10 January 2022

BLM Office Renovations
Pearl Public School District – Pearl, MS

ADDENDUM NO. 01

TYP. METAL WALL PANELING ON WD. STUD FRAMING EXTERIOR WALL ASSEMBLY:

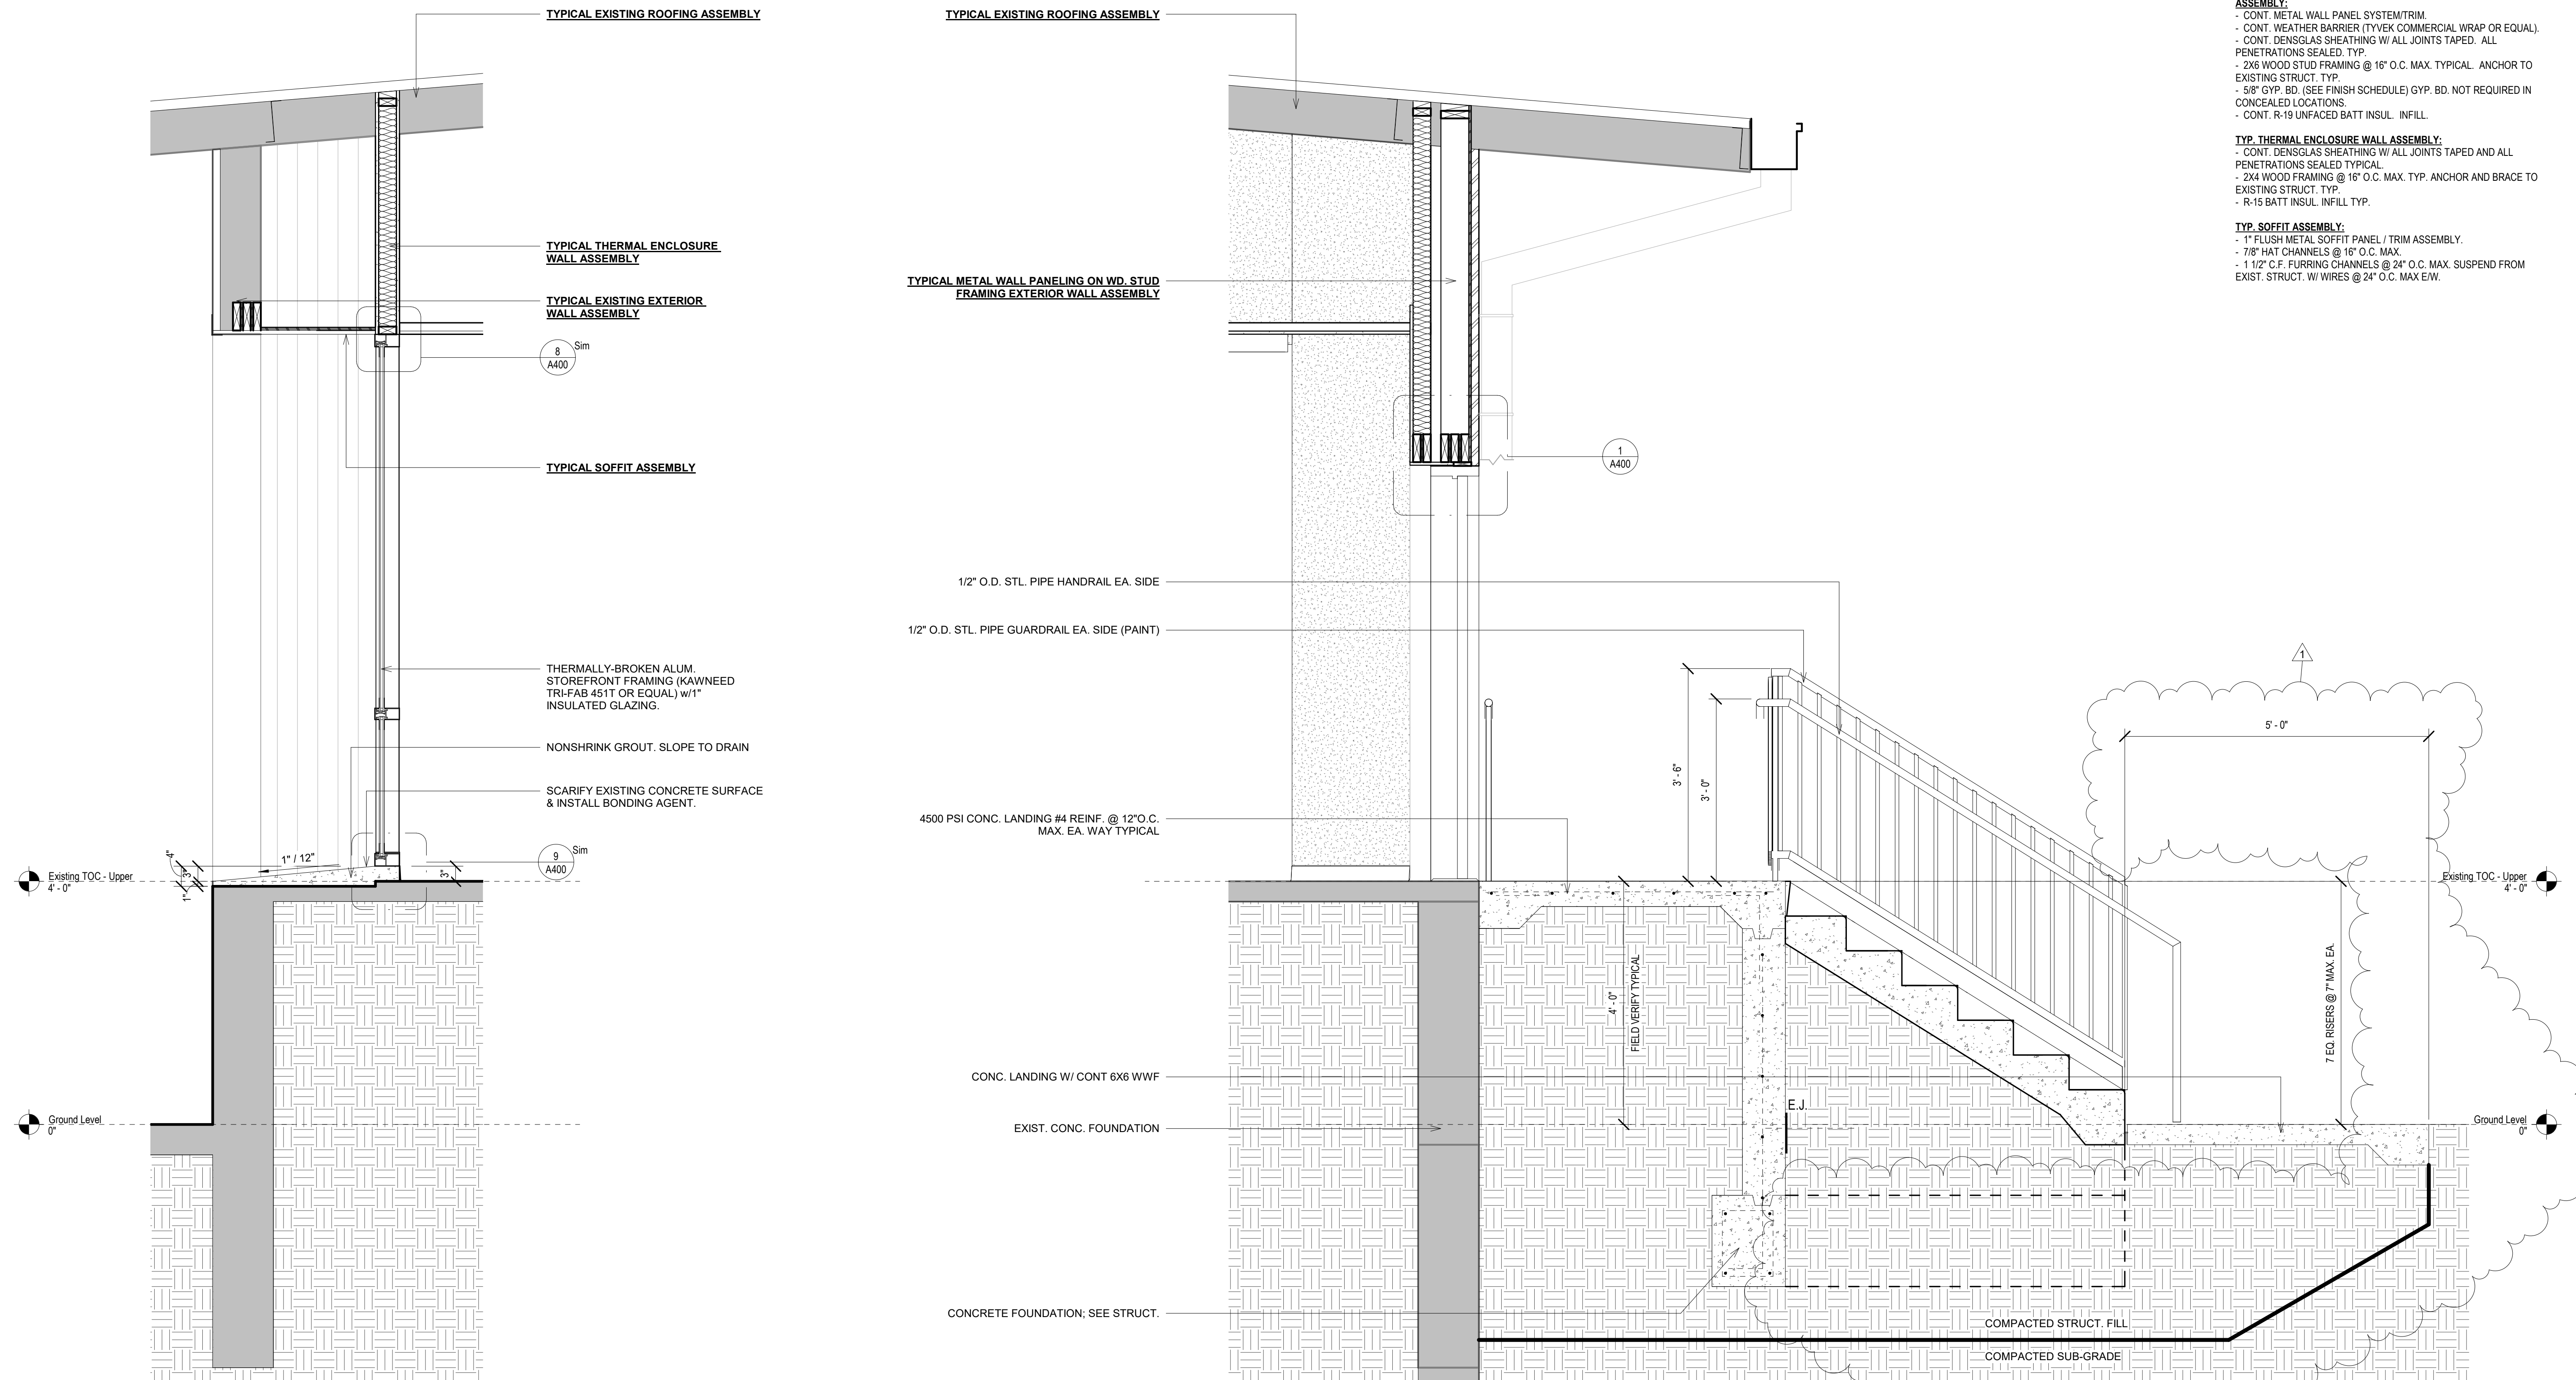
| ITEM NO. 9 | <p>A300 WALL SECTIONS</p> <p>A301 WALL SECTIONS</p> <p>A302 WALL SECTIONS</p> <p>A303 WALL SECTIONS</p> <p>Revise per the enclosed sheets.</p> |

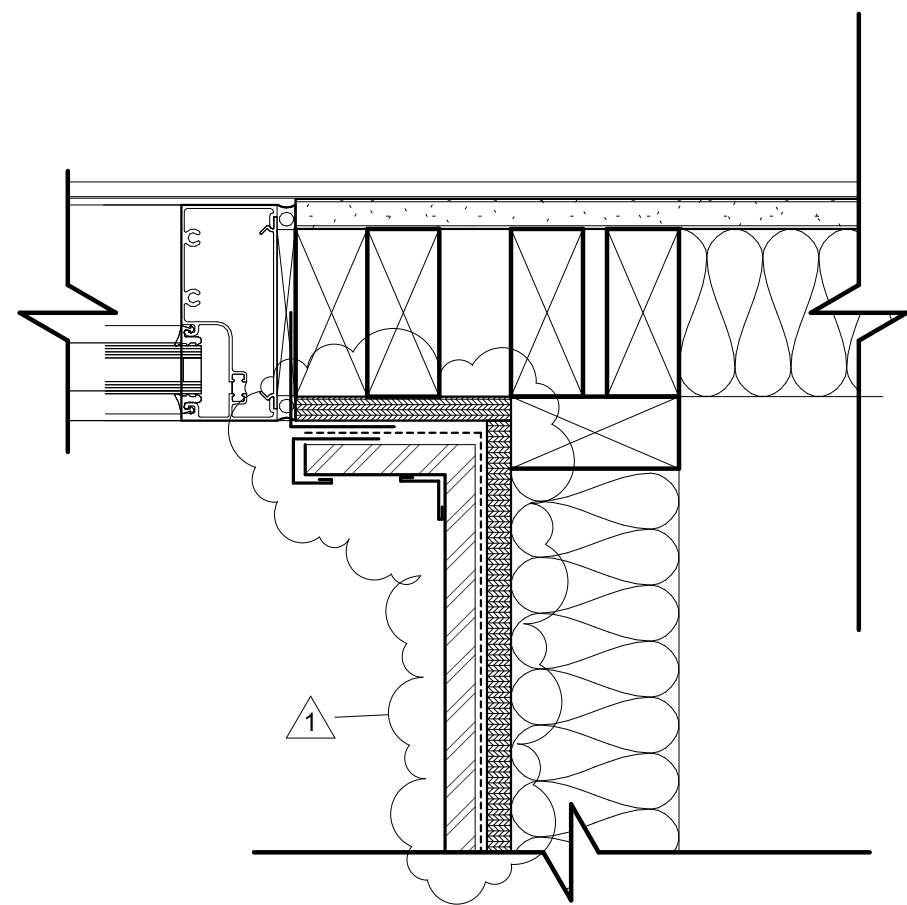
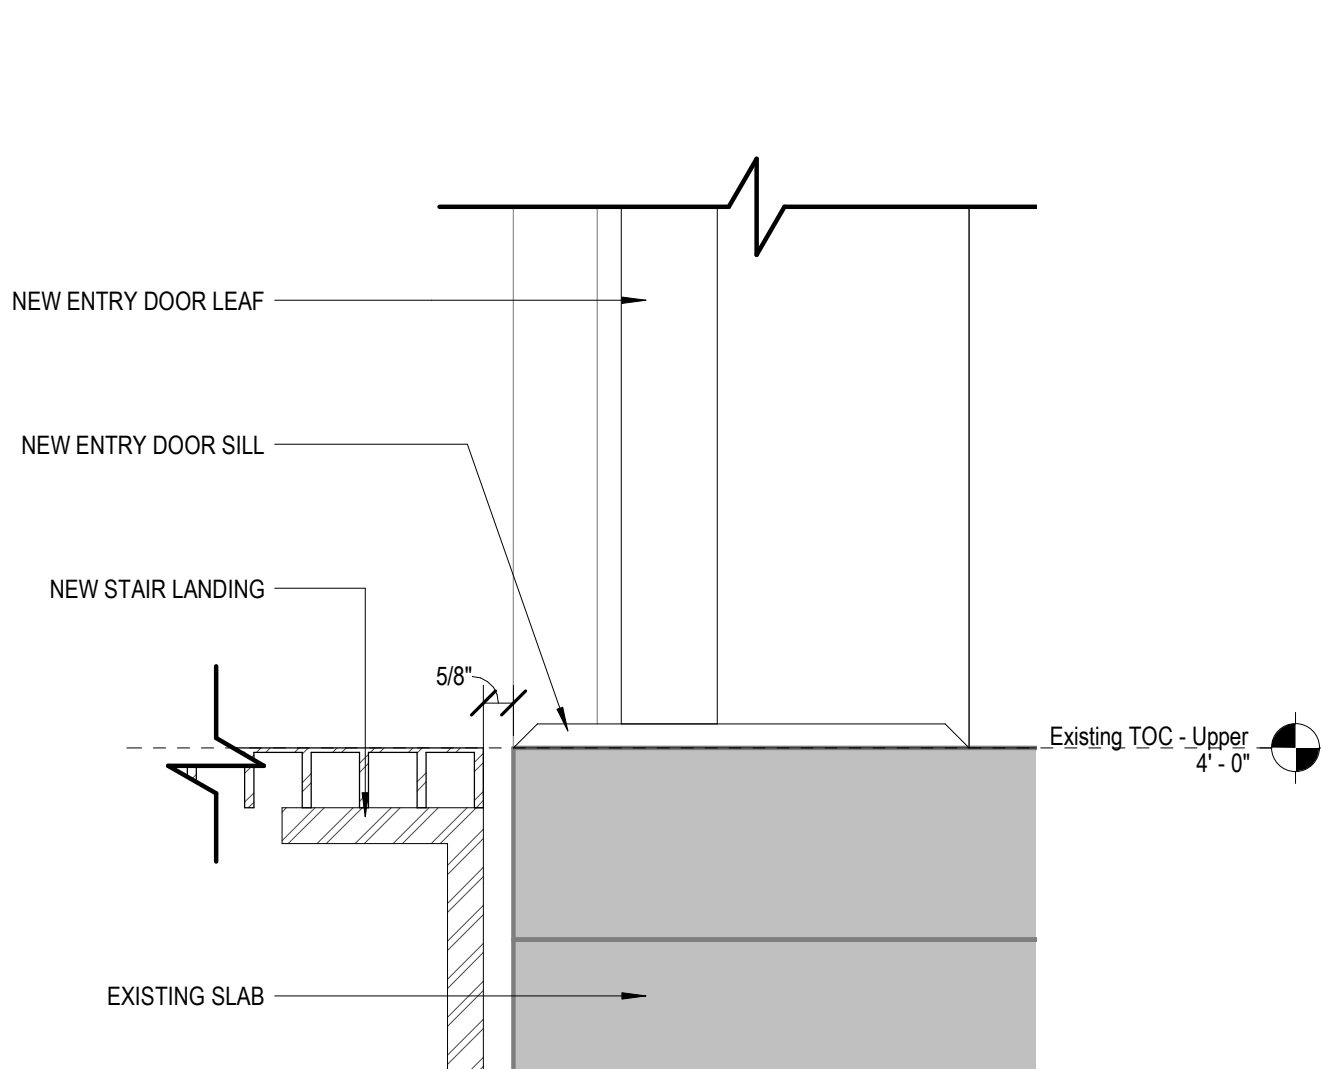
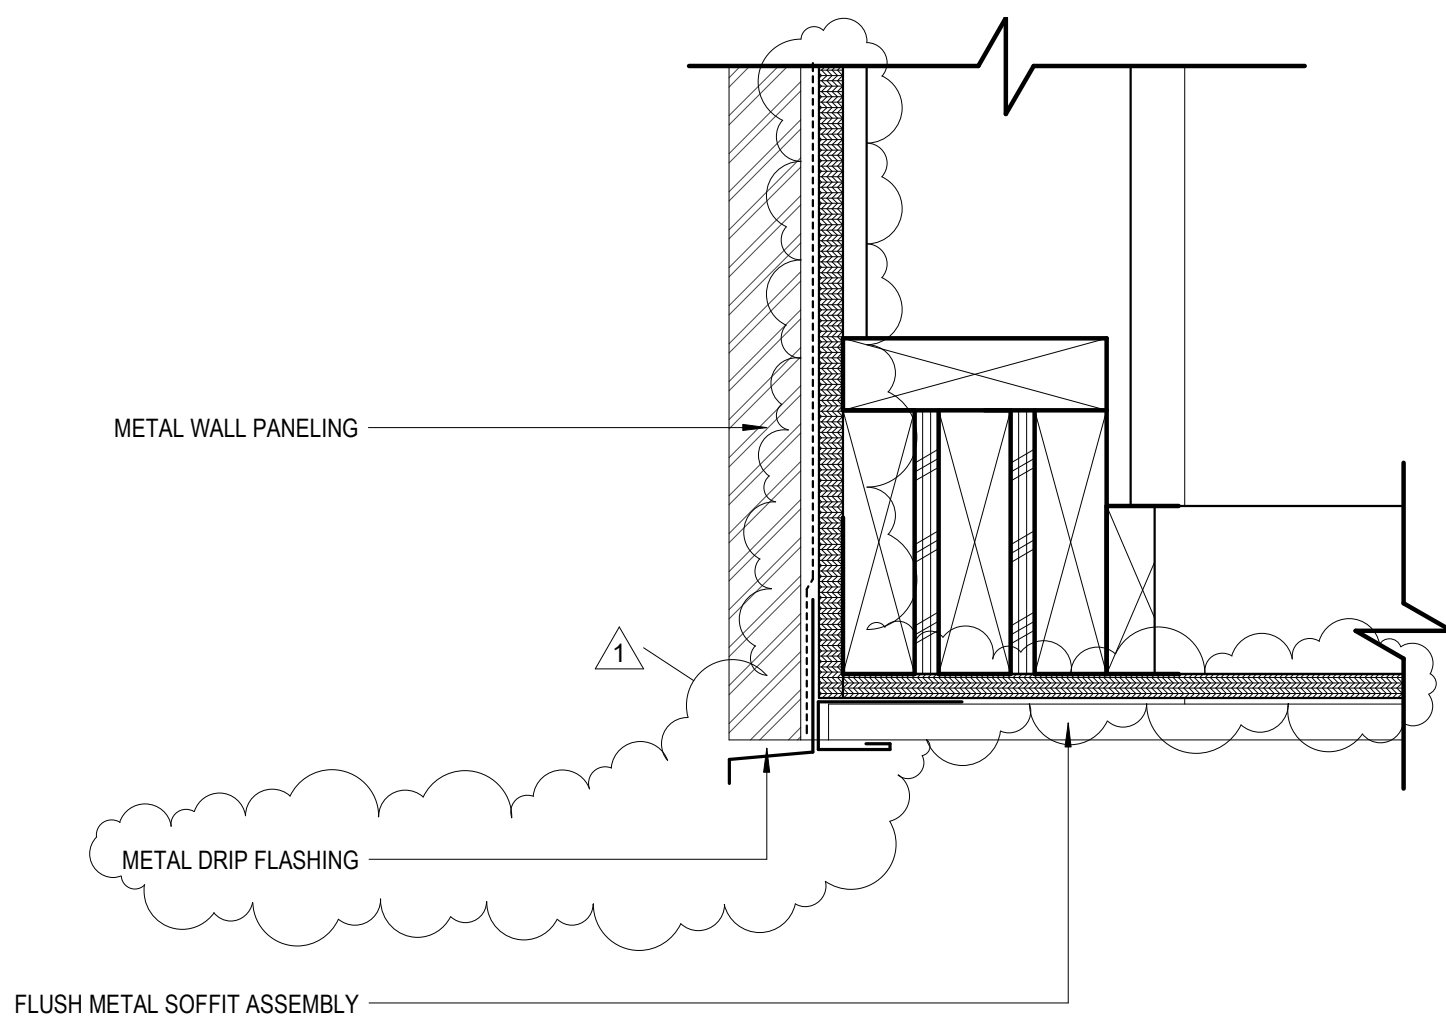
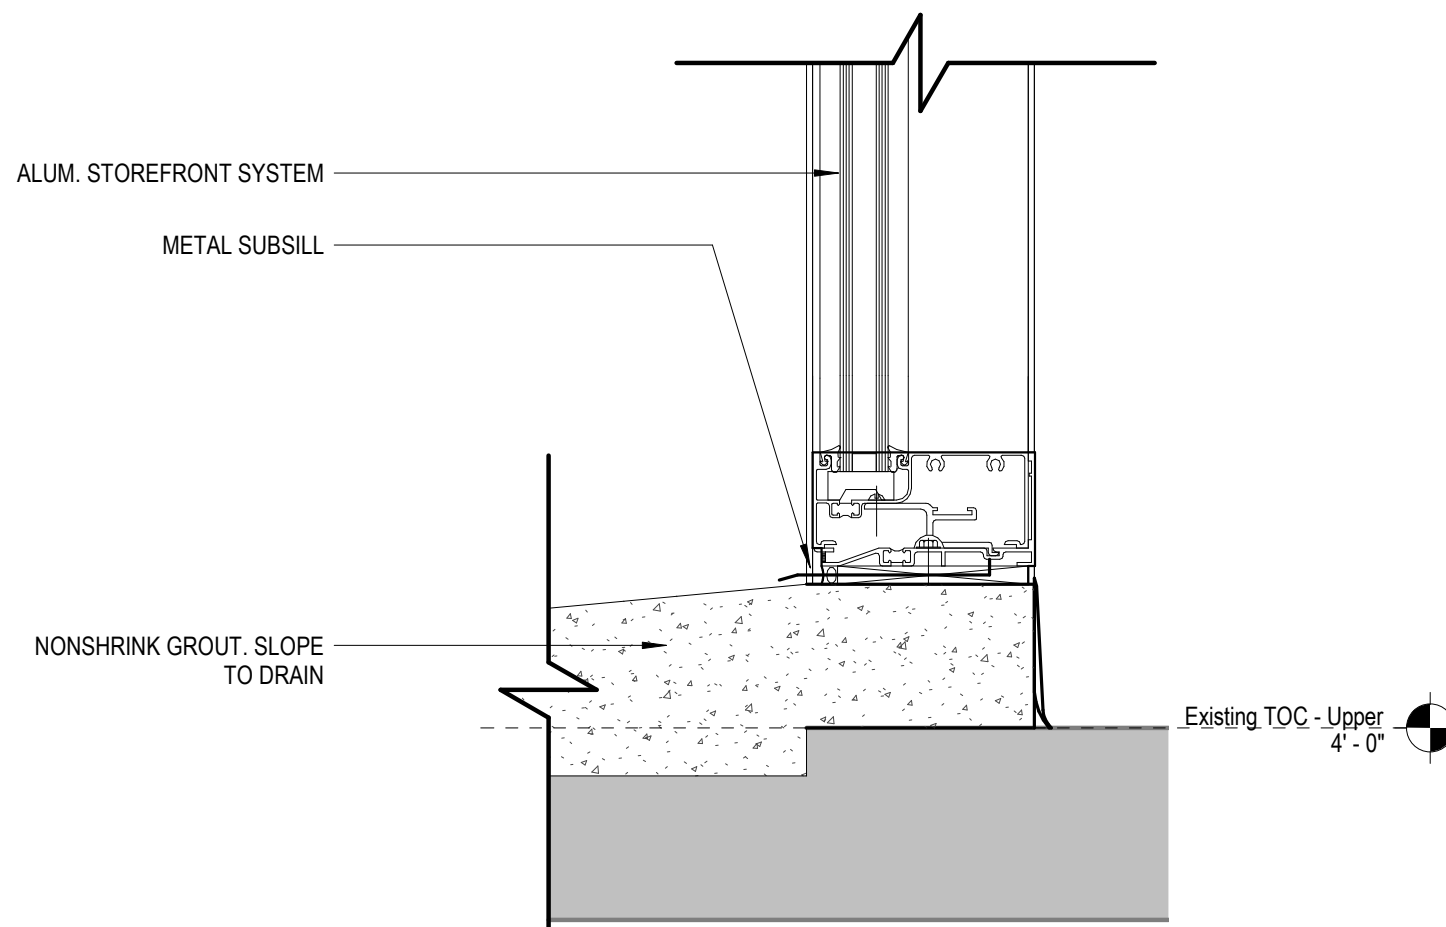
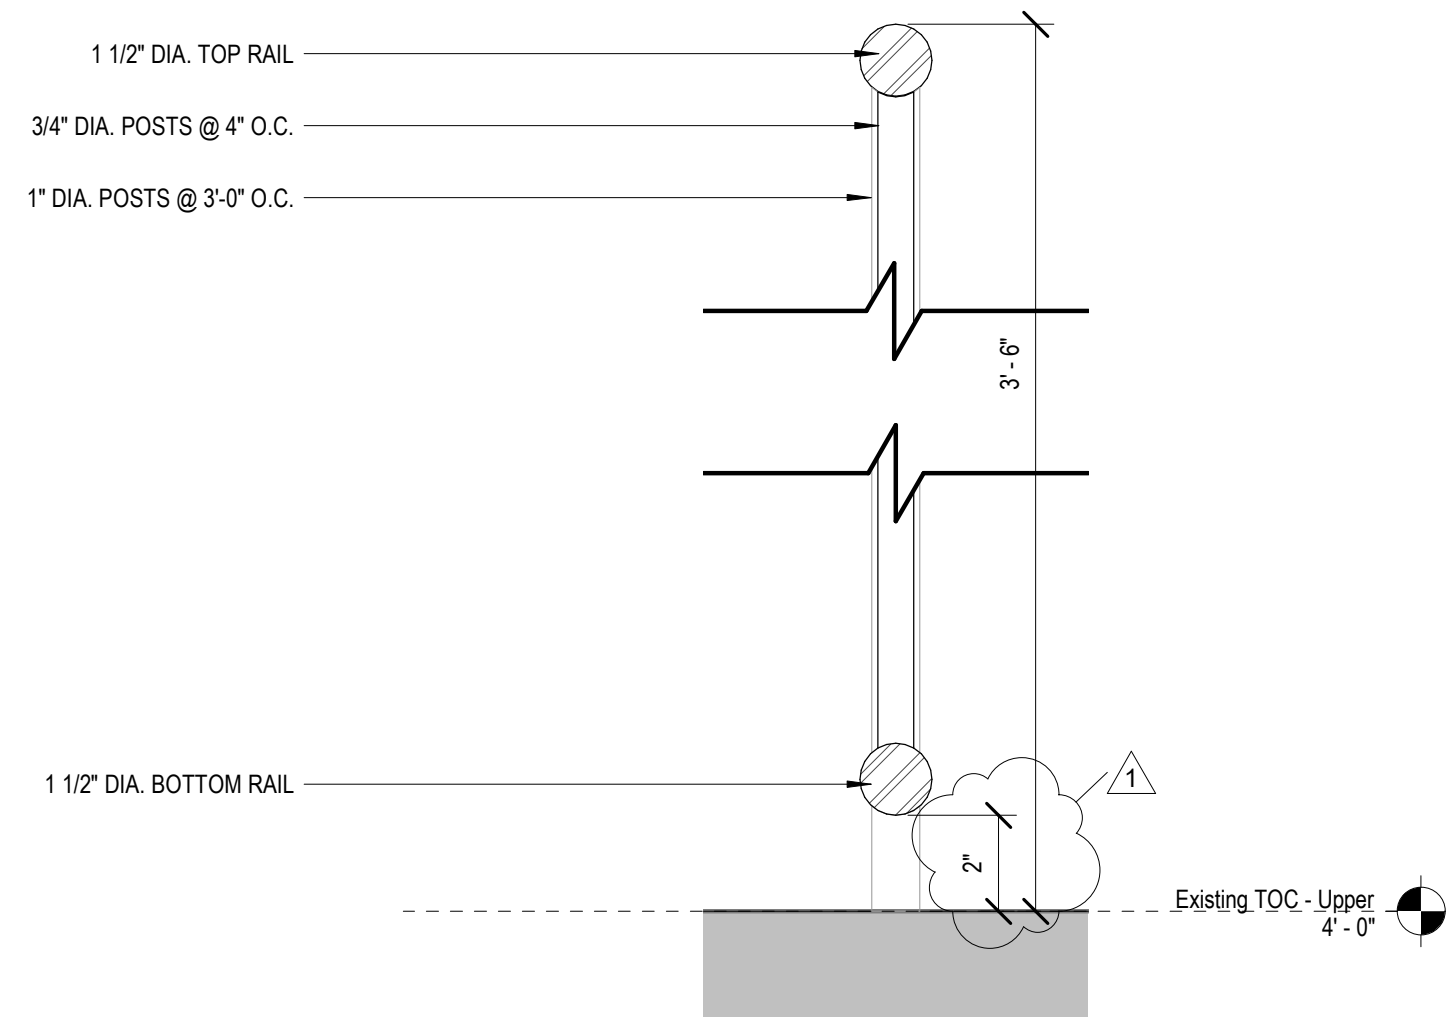
| ITEM NO. 10 | <p>A400 DETAILS</p> <p>Revise per the enclosed sheet.</p> |
